Dublin Cycling Campaign,
% Tailor's Hall,
Back Lane,
Dublin 8

Clonsilla SHD - 309622

11th April 2021

IMAGE 1 PE18105-CWO-01-ZZ-DR-A-006002- Bicycle Storage Compound

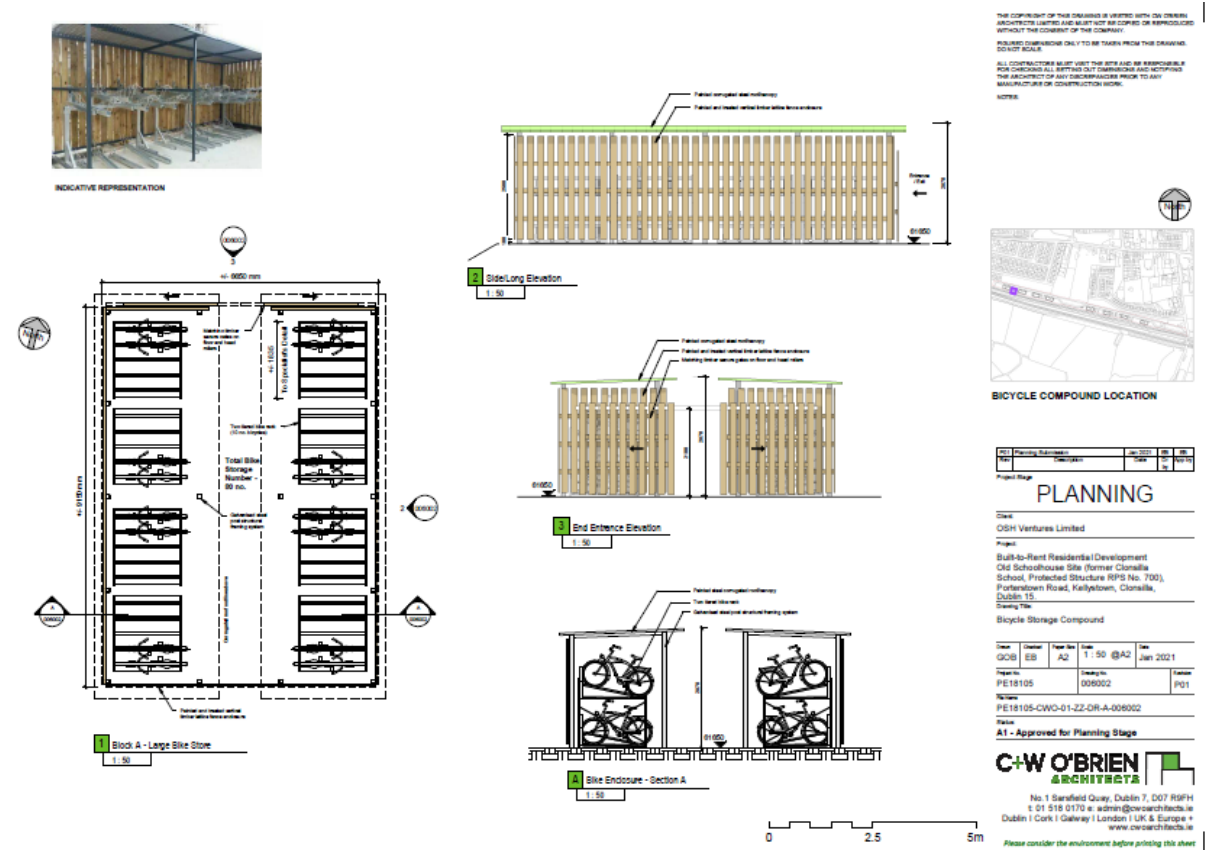
Standards for New Apartments 2018. The bike storage facilities shown in **Image 1**, taken from document **PE18105-CWO-01-ZZ-DR-A-006002- Bicycle Storage Compound**, states all 80 bike parking spaces are located beside block A. It is unclear if these are visitor bike parking facilities or residential. If it is visitor parking in one location for a site that spans over approx 2 km long development would not be considered to be efficient or a network of parking facilities, direct or convenient as stated in Fingal development plan, See APPENDIX I.

- In **image 2** below it states that item number 16 in the index for Block A in document **PE18105-CWO-01-ZZ-DR-A-002111- Block A - GA Elevations, Sections**. Unfortunately there is no item labelled as 16 in the diagram within this document so we cannot comment on the design of bicycle parking if the image is not provided. This is an omission from Osh Ventures limited.

IMAGE 3: 19160-15C PROPOSED ROAD MARKING AND SIGN LAYOUT

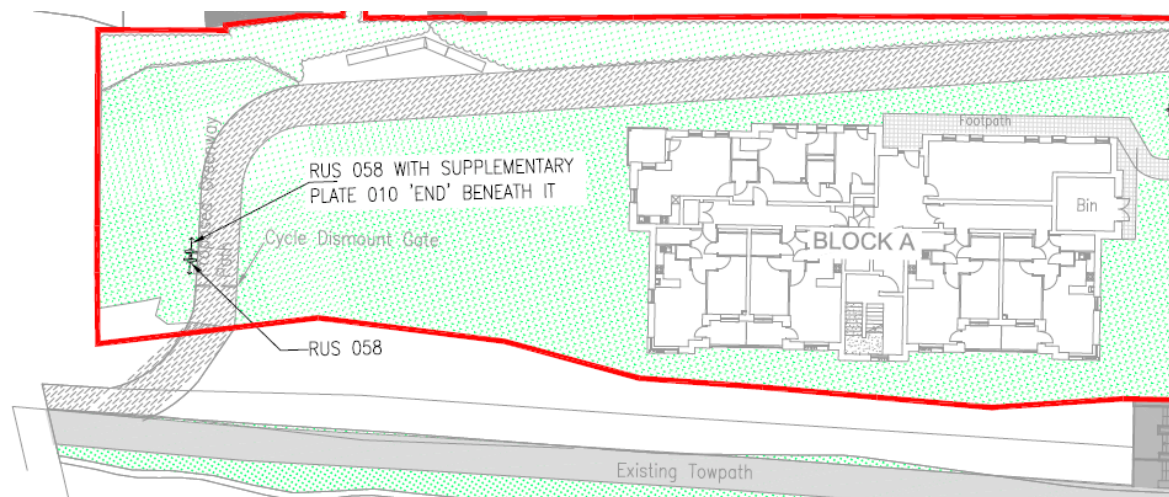
At the western end of the development a cycle dismount gate is proposed as part of the plans as shown in Image 3 taken from **19160-15C PROPOSED ROAD MARKING AND SIGN LAYOUT**

- Fingal Cycling Campaign does not know where the Osh Ventures Limited has got the designs for a dismount gate. They are not recommendations from the National Cycle Manual or Design Manual for Urban roads and streets (DMURS). They are also discriminatory against less well able bodied people and non standard bicycles such as cargo bikes and trailers with kids in tow. The gate prevents people from accessing the Royal Canal.

- Fingal Cycling Campaign recommends access control as shown in **Image 4** taken from Transport Infrastructure Ireland (TII) guidance document on rural cycle design. Ensuring cyclists are not made to dismount to access the cycleway is a key objective of TII. The gate detailed below provides better access for all types of users.

Image 6: Large amount of trees and shrubs blocking access to proposed new pedestrian and cycle bridge **PP252-02 Detailed Landscape**

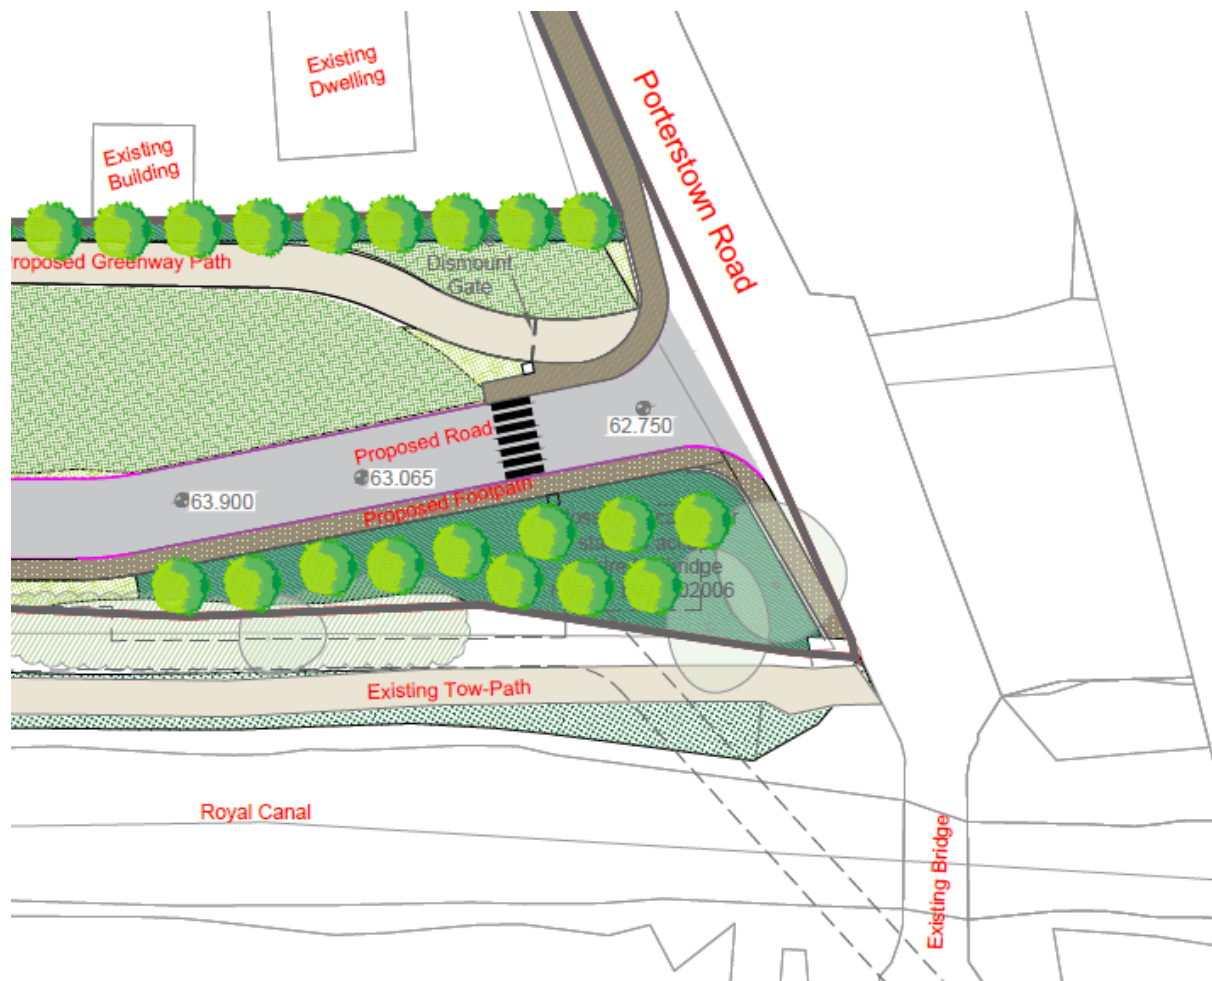
As someone who regularly uses this route to travel to work on my morning commute this road is full of pedestrians, cyclists, parents with buggies and prams. Usually, the large numbers take up the whole span of Kennan bridge over the royal canal. Many people are also waiting on the south side of the road waiting for the level crossing to open up after a train(s) have passed. This situation will be made worse when the level crossing is closed and the desire line for pedestrians and cyclists movement will move directly in front of the new entrance to the Old school house development. There isn't any detail of how Osh Ventures Limited proposed to handle these large numbers over the approx 30 minute window of children travelling to school. Will there be a traffic light system in place at the entrance? Will cars wait for pedestrians to cross the road before exiting the site or will vehicles have priority at this location? There is a zebra crossing at the entrance shown in the promotional video on the website www.clonsilla.shd.ie but there is a large bush preventing direct access to the bridge and when you have large numbers of people crossing at approx the same period of time in the morning this design is not workable in the real world. It's not clear layout and in practice pedestrians and cyclists are vulnerable road users and will lose priority on their school commute. Please refer to detailed **Image 6 PP252-02 Detailed Landscape**

We welcome the segregated shared cycle and pedestrian path along the Porterstown road and is safe for cycling for all ages and abilities. The shared path lane in colour grey is highlighted in . Image 6 was taken from . There is no reference to the width of the path. Is it 3 meters or 4 meters? Is it less than 3 meters wide? It would be best to have a 4 meter width as it is shared for most of it. The National Cycling Manual recommends a **minimum** of 3 meters for shared spaces.

Image 8 : 133967-sk1003-A Future Site Access Alteration

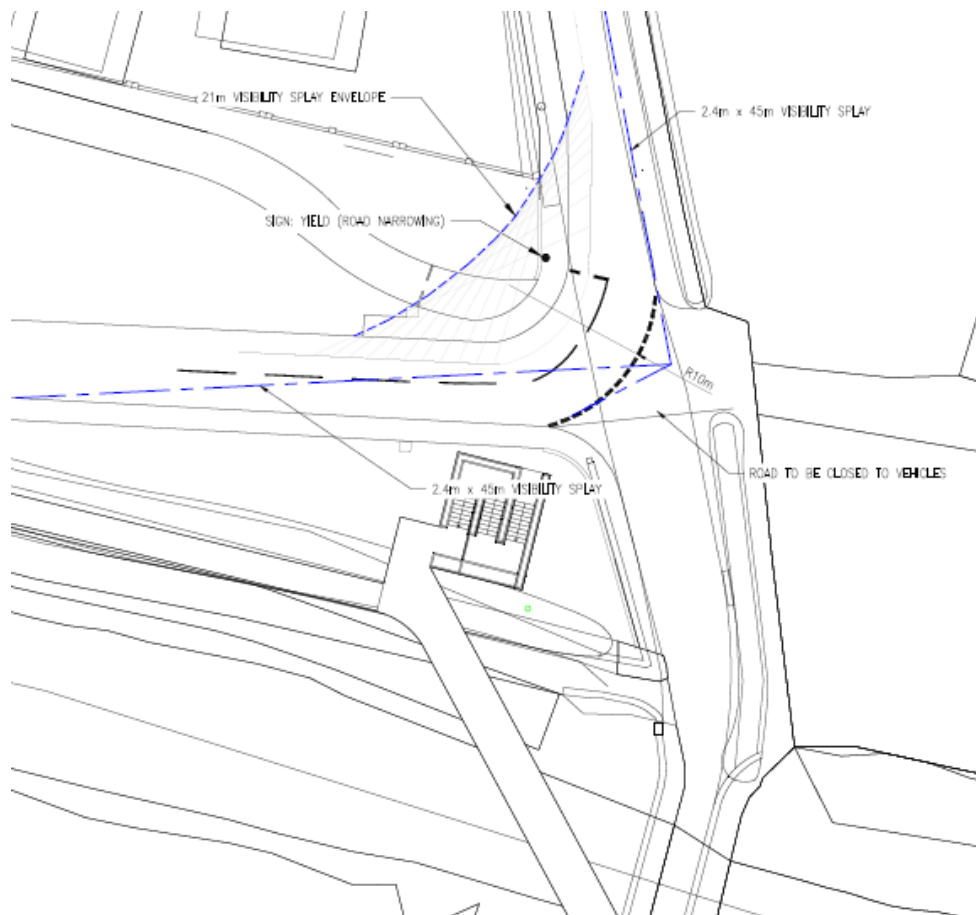
Fingal Cycling Campaign doesn't understand why proposed alteration to exit as shown in documents **133967-sk1003-A Future Site Access Alteration** and **Image 8** is different to road layout in detailed master plan documents (**Image 6**) and promotional video on the website. Does Osh Ventures limited have permission to change the road layout when Kennan bridge and level crossing is closed by Dart+West? This would make speeds faster at this turning and reduce the corner radii as recommended by DMURS.
